MC LAREN TRAFFIC ENGINEERING

12th November 2020

Reference: 200818.02FA

LETTER OF RESPONSE TO COUNCIL COMMENTS FOR WOOLSTORE MASTERPLAN DEVELOPMENT AT 57 ANNIE STREET, WICKHAM

ANNEXURE B: SWEPT PATH TESTING
(Sheet 2 of 10)

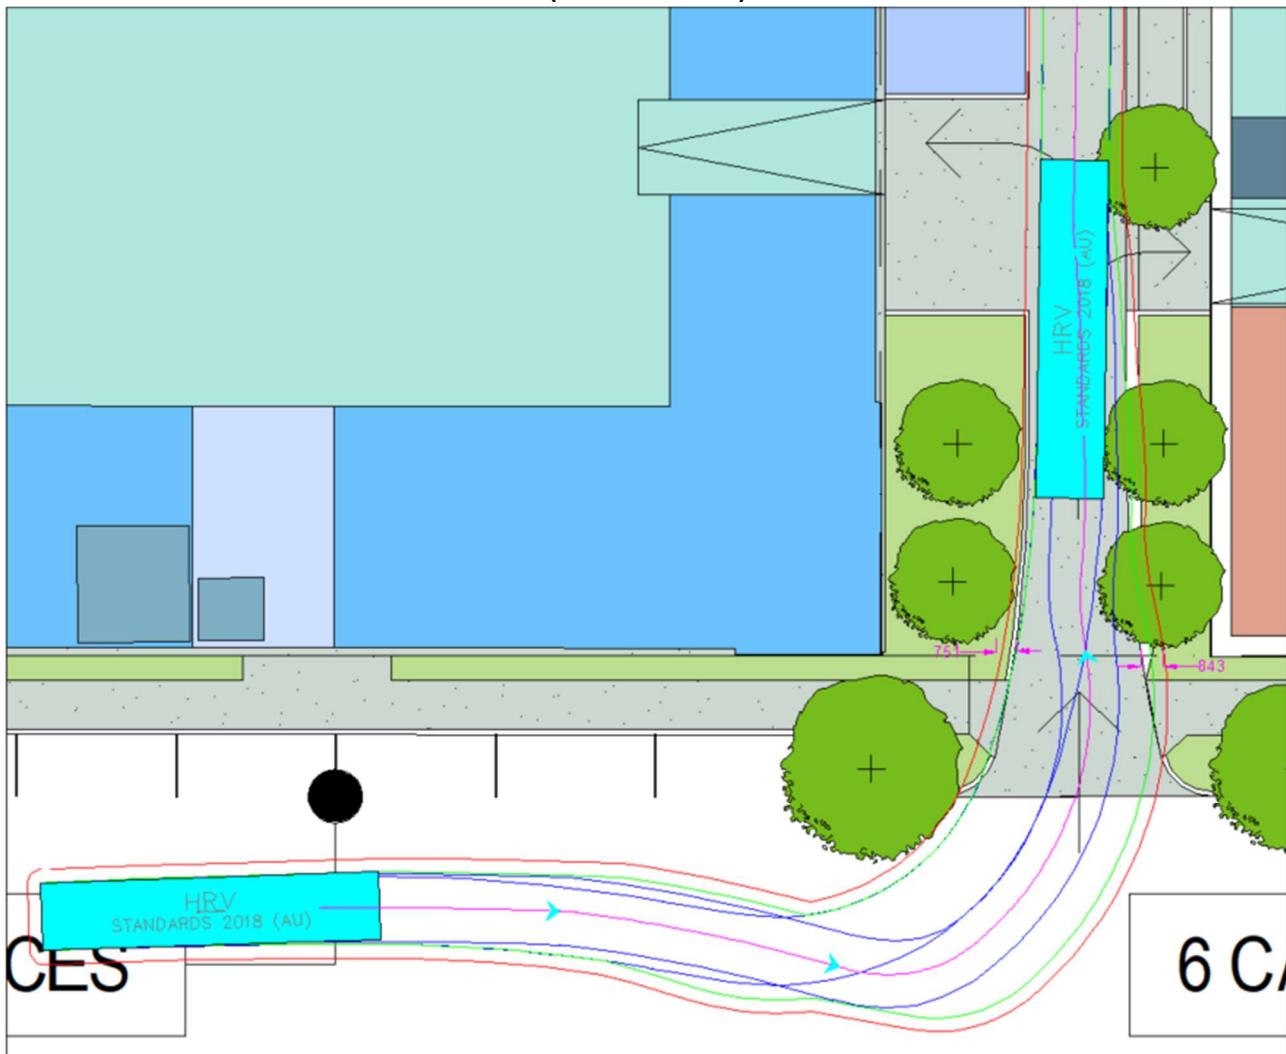
HRV LEFT TURN FROM ANNIE STREET TO INTERNAL ROAD BETWEEN WOOLSTORES 2 AND 3

Successful – subject to minor landscaping and driveway changes which can be addressed at the detailed design stage.

ANNEXURE B: SWEPT PATH TESTING
(Sheet 3 of 10)

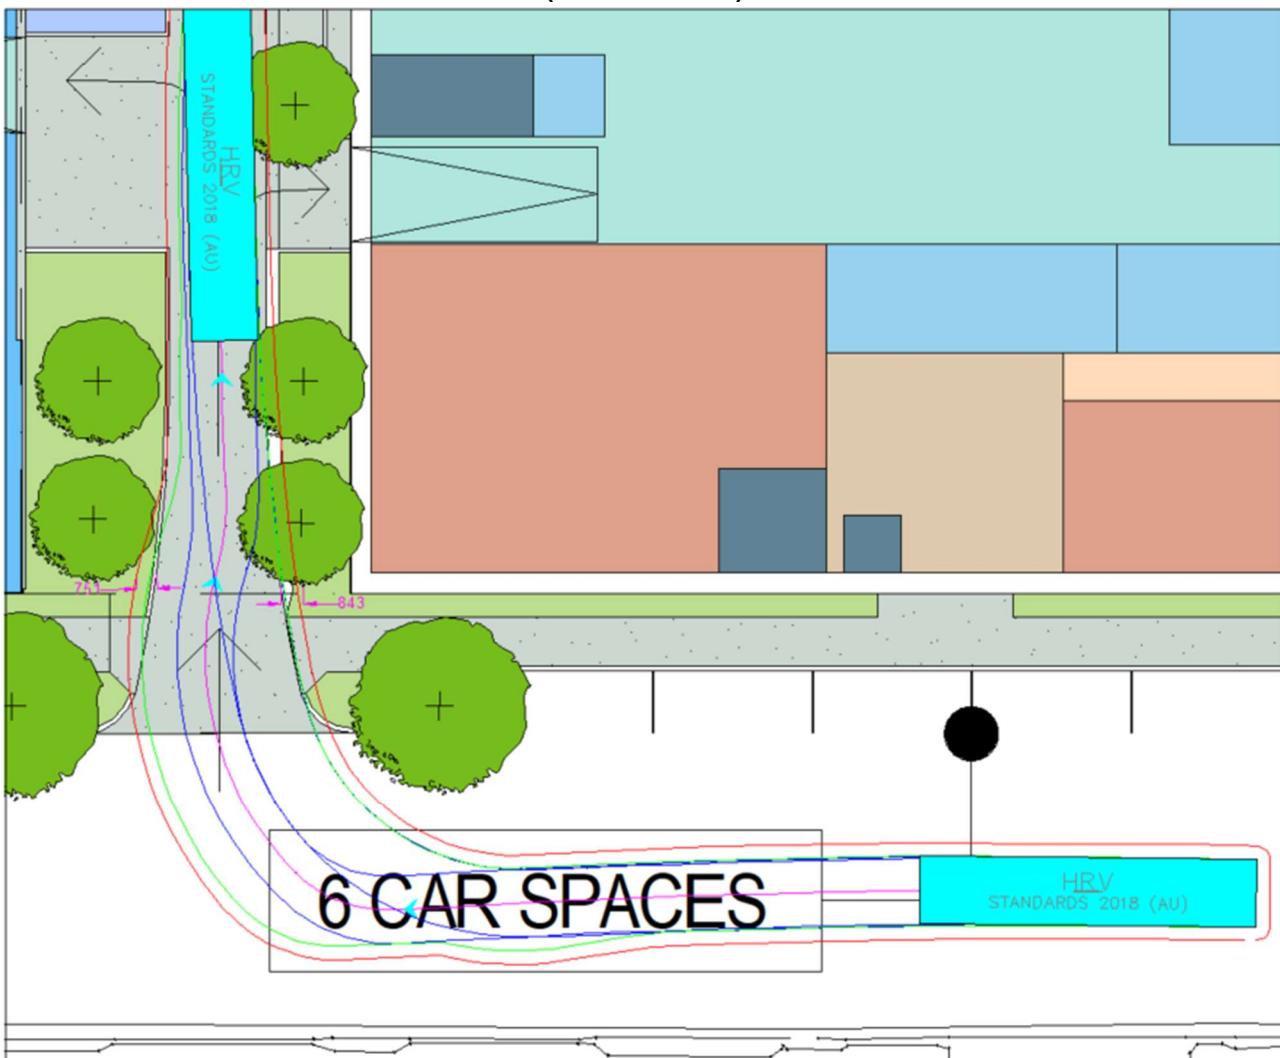
HRV RIGHT TURN FROM ANNIE STREET TO INTERNAL ROAD BETWEEN WOOLSTORES 2 AND 3

Successful – subject to minor landscaping and driveway changes which can be addressed at the detailed design stage.

ANNEXURE B: SWEPT PATH TESTING
(Sheet 4 of 10)

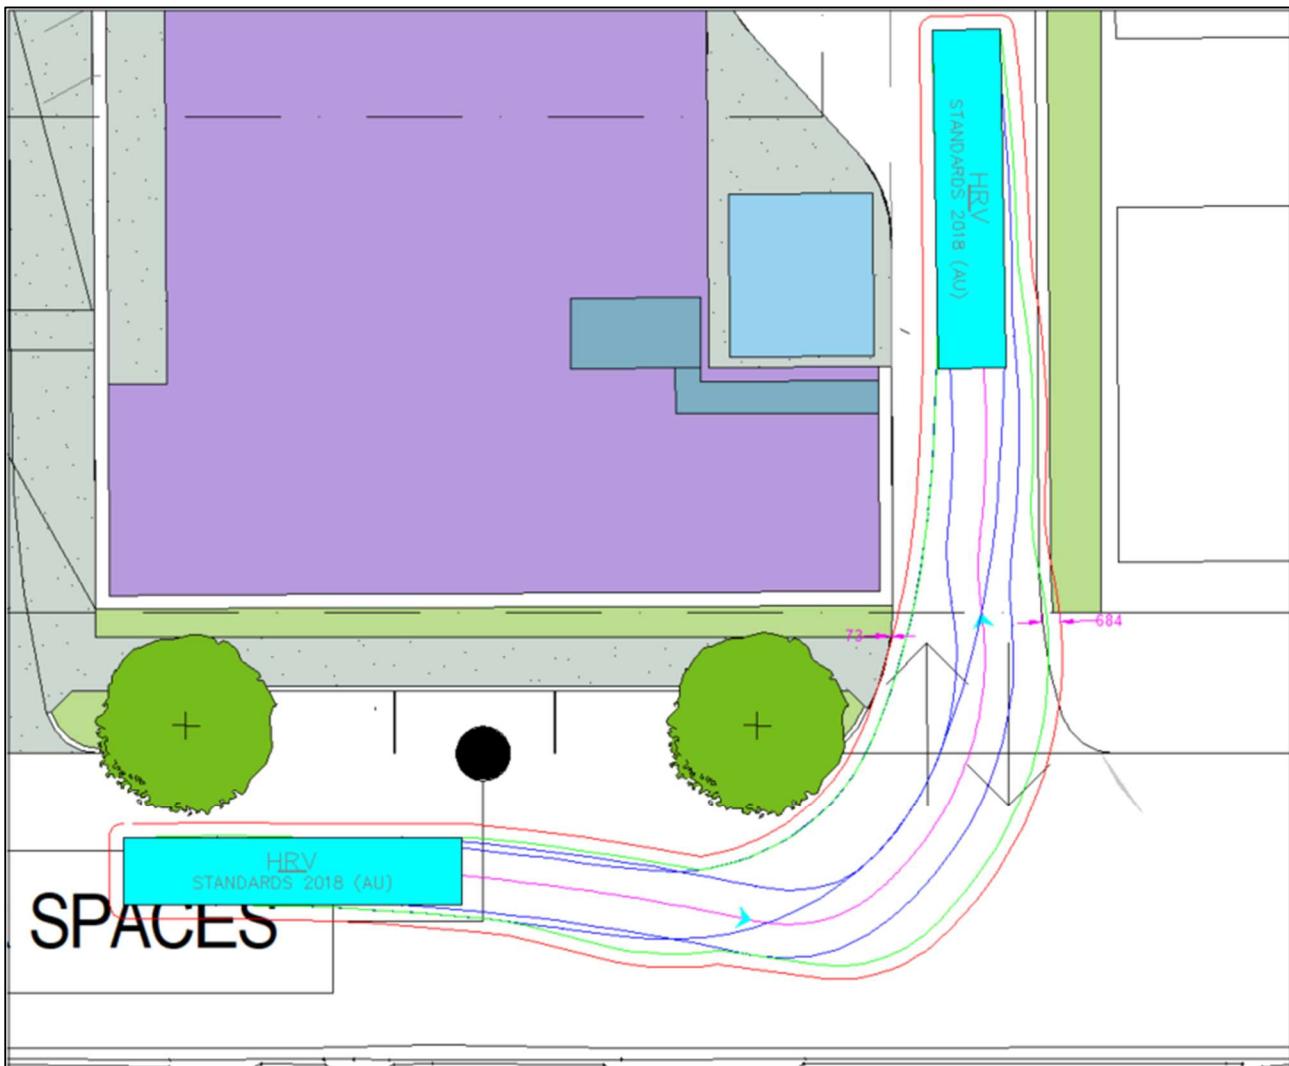
HRV LEFT TURN FROM ANNIE STREET TO INTERNAL ROAD AT THE EAST OF BUILDING 4

Successful – subject to minor landscaping and driveway changes which can be addressed at the detailed design stage.

Note: This internal road is not proposed to be used for HRV access, but these swept paths are included regardless to address Council request for HRV access of “remaining access roads”.

ANNEXURE B: SWEPT PATH TESTING
(Sheet 5 of 10)

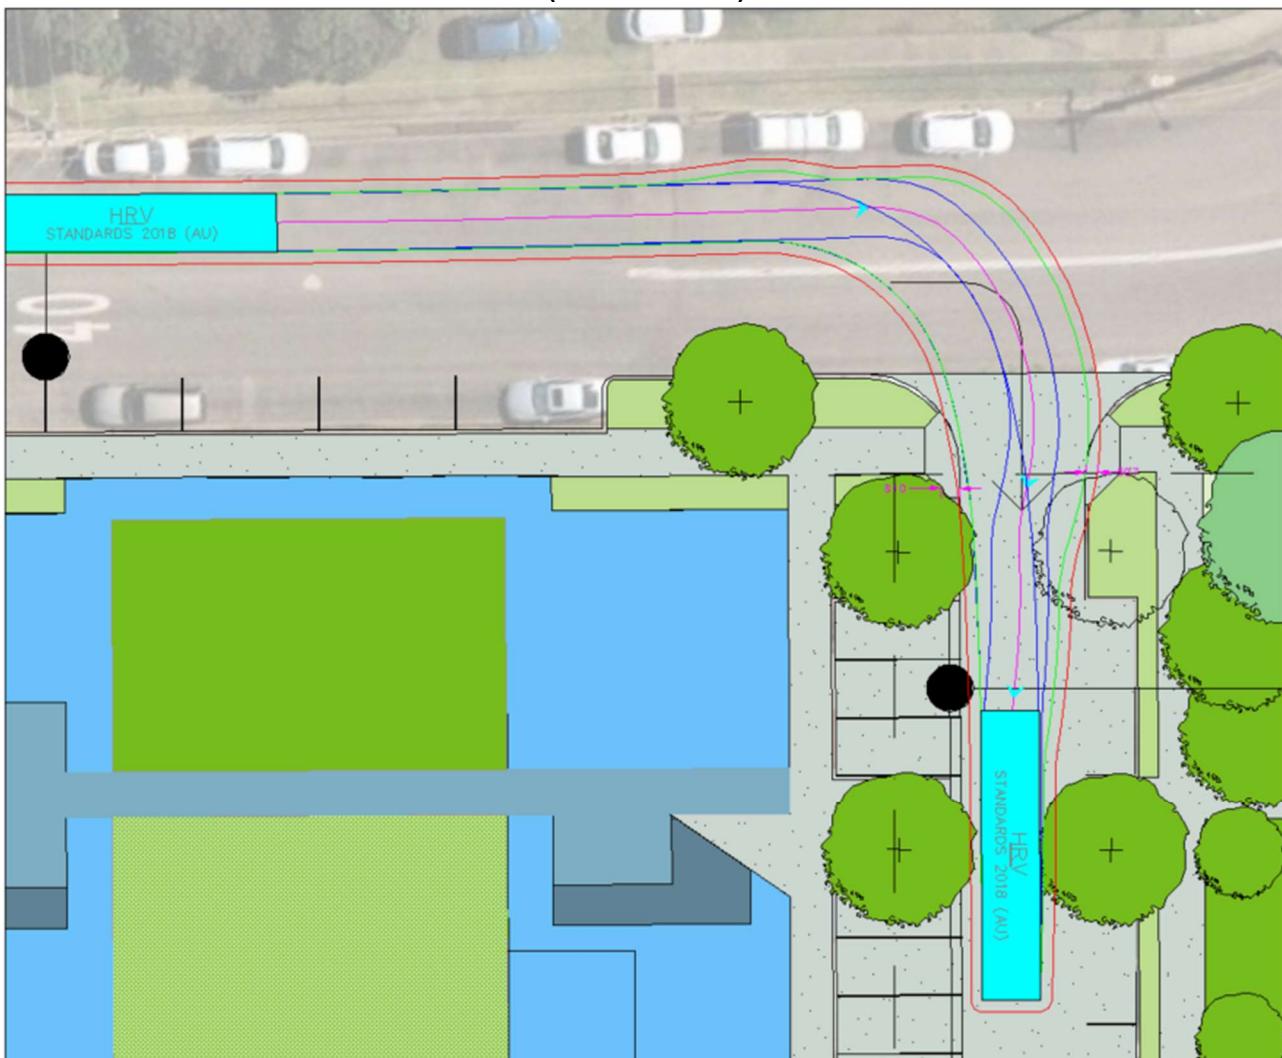
HRV RIGHT TURN FROM ANNIE STREET TO INTERNAL ROAD AT THE EAST OF BUILDING 4

Successful – subject to minor landscaping and driveway changes which can be addressed at the detailed design stage.

Note: This internal road is not proposed to be used for HRV access, but these swept paths are included regardless to address Council request for HRV access of “remaining access roads”.

ANNEXURE B: SWEPT PATH TESTING
(Sheet 6 of 10)

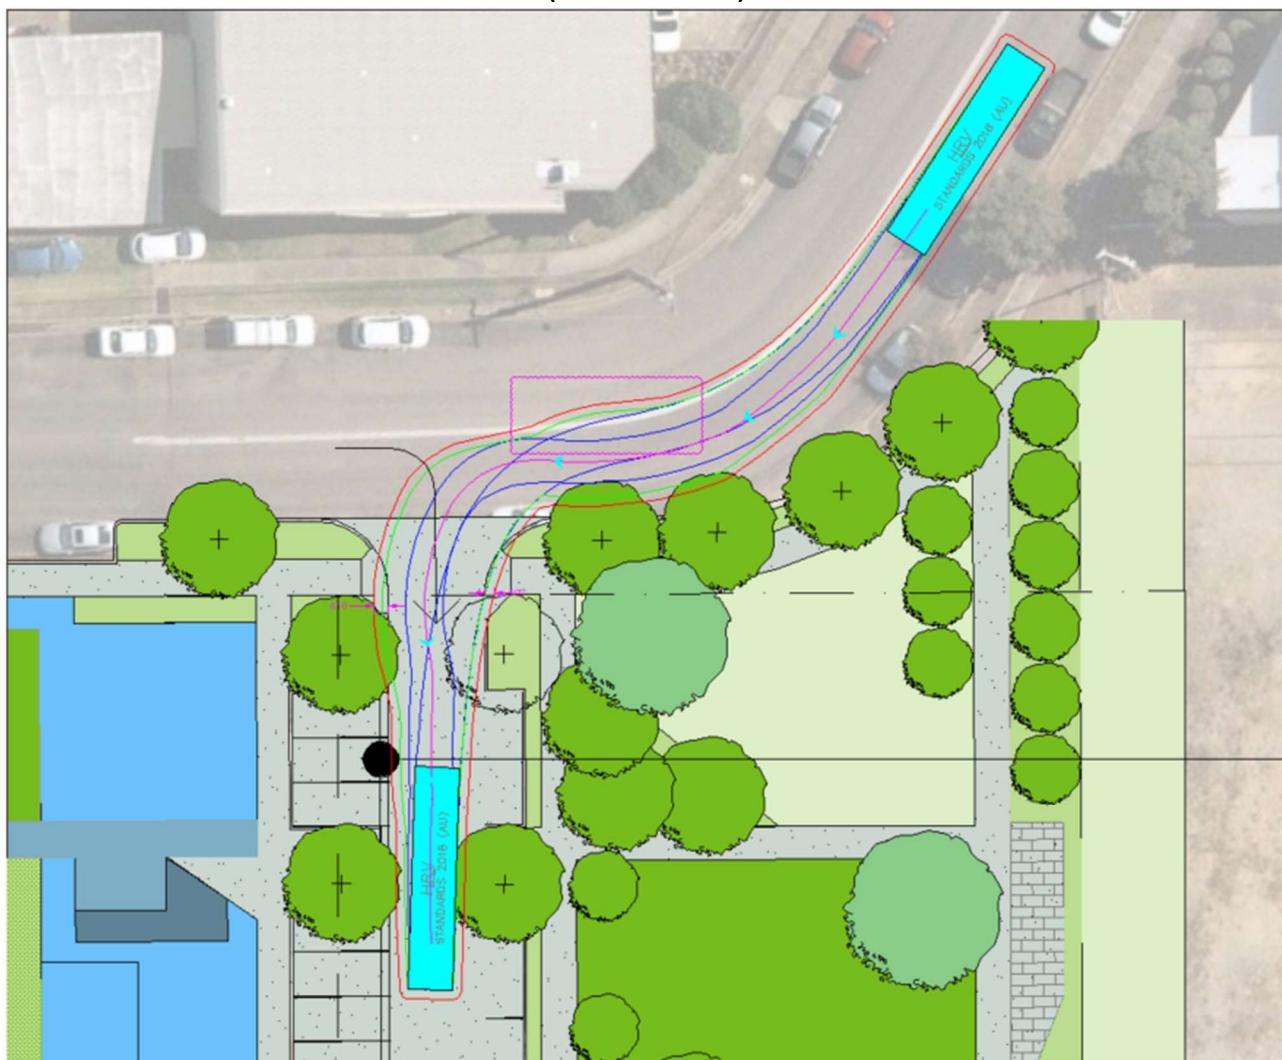
HRV RIGHT TURN FROM THE AVENUE TO INTERNAL ROAD TO THE EAST OF BUILDING 5

Successful – subject to minor landscaping and driveway changes which can be addressed at the detailed design stage.

ANNEXURE B: SWEPT PATH TESTING
(Sheet 7 of 10)

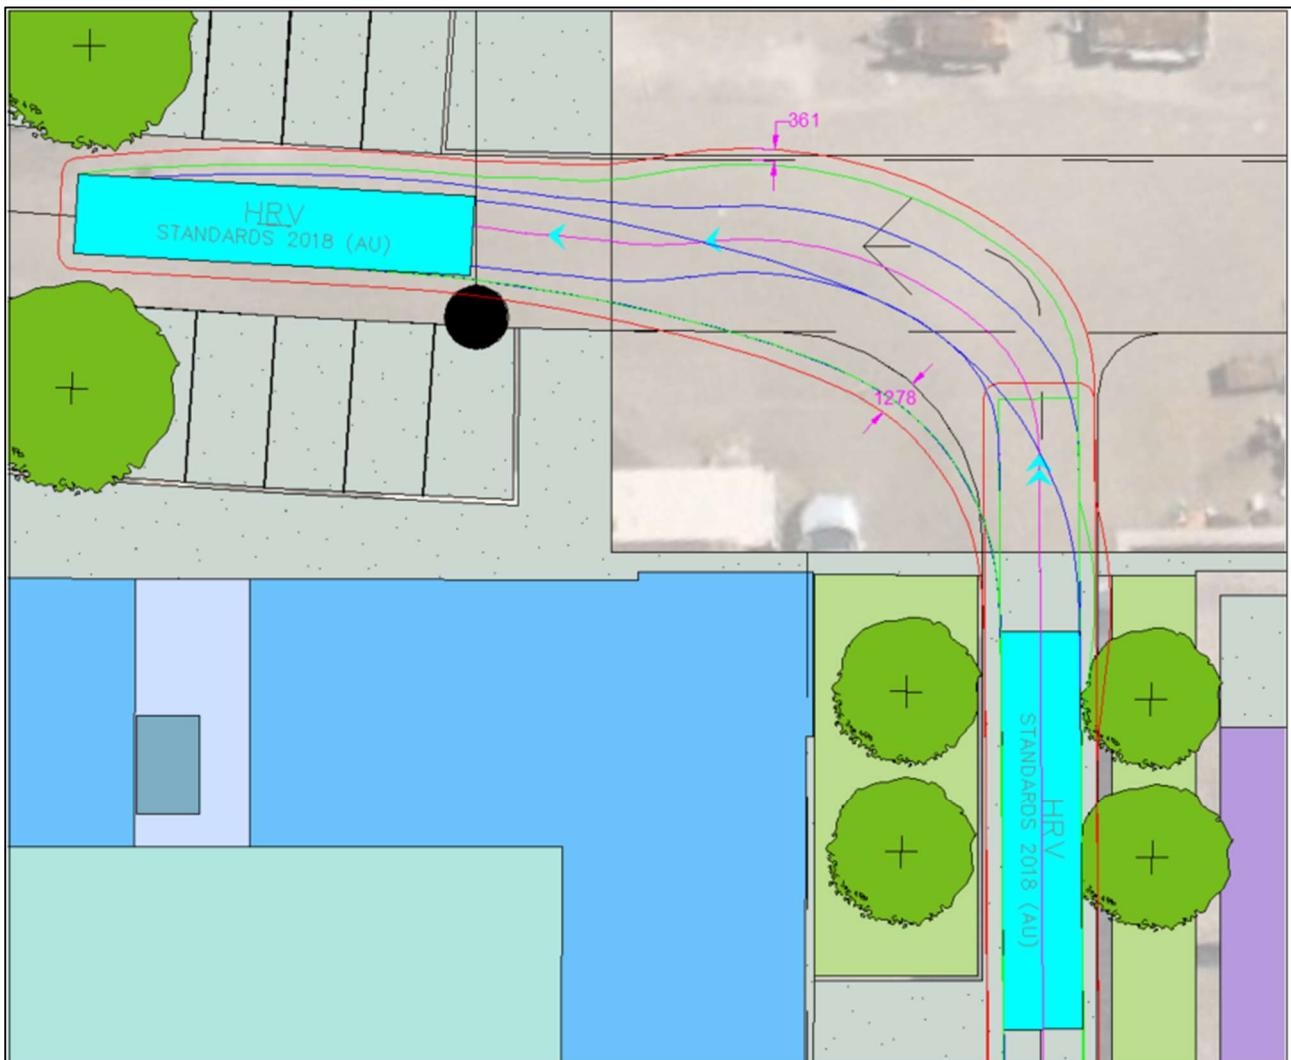
can successfully enter the site via almost all the proposed routes and circulate the internal roads of the site, subject to minor landscaping and localised roadway widening changes near the intersection of the internal roads. This is with the exception of a HRV making a left turn from The Avenue to the internal road located to the east of Building 5. Due to the existing road layout of The Avenue, the required manoeuvre by a HRV would encroach past the centreline of The Avenue which is unacceptable.

HRV LEFT TURN FROM THE AVENUE TO INTERNAL ROAD TO THE EAST OF BUILDING 5

Unsuccessful – crosses centreline of The Avenue

ANNEXURE B: SWEPT PATH TESTING
(Sheet 8 of 10)

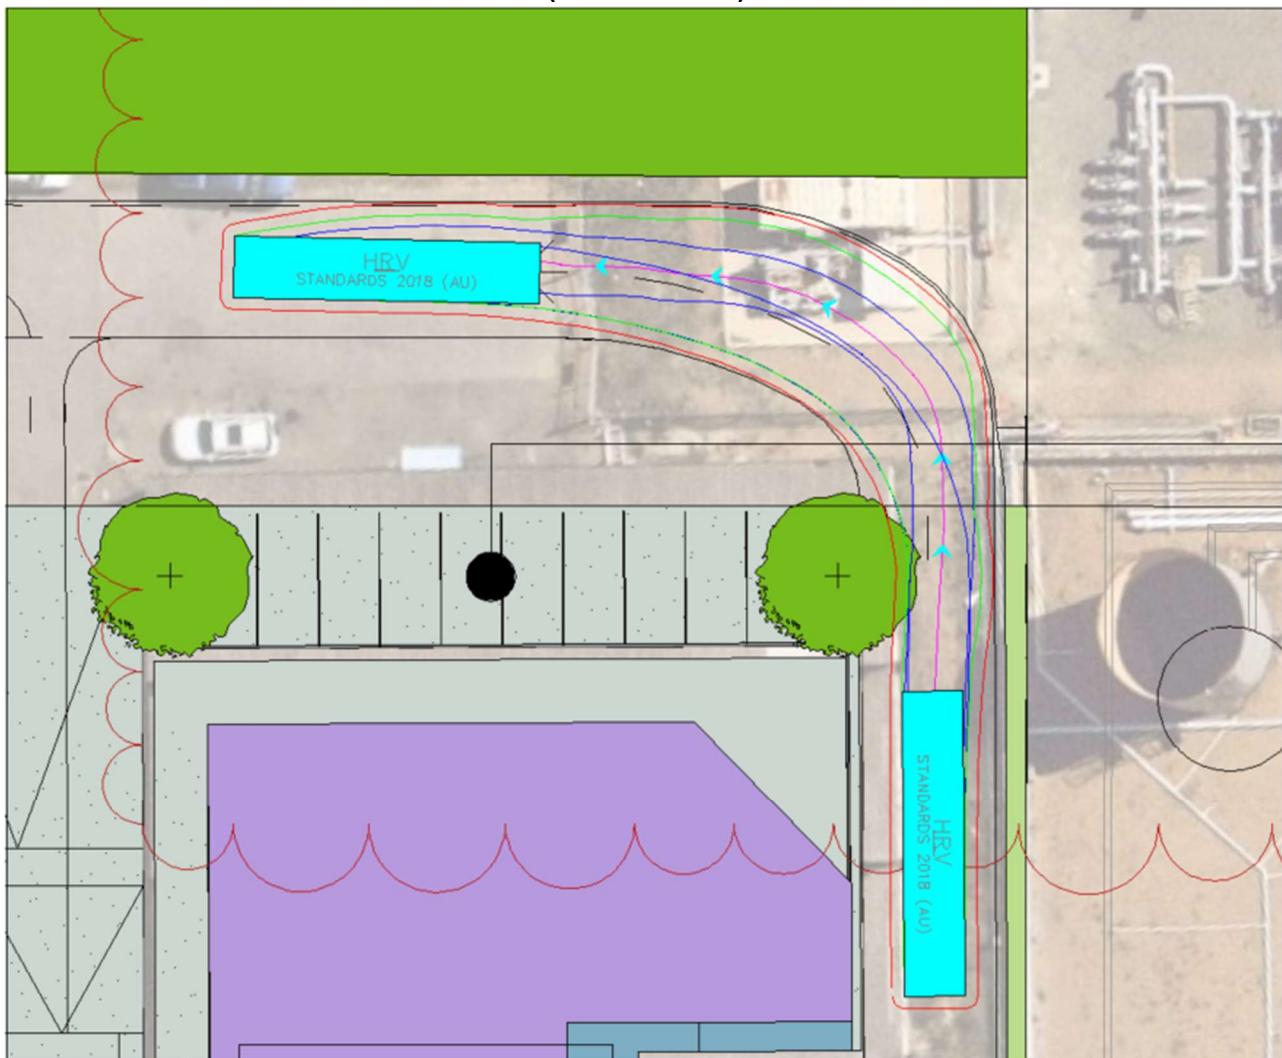
HRV LEFT TURN FROM INTERNAL ROAD BETWEEN WOOLSTORES 2 AND 3 TO THE EAST-WEST INTERNAL ROAD

Successful – subject to minor landscaping and intersection changes which can be addressed at the detailed design stage.
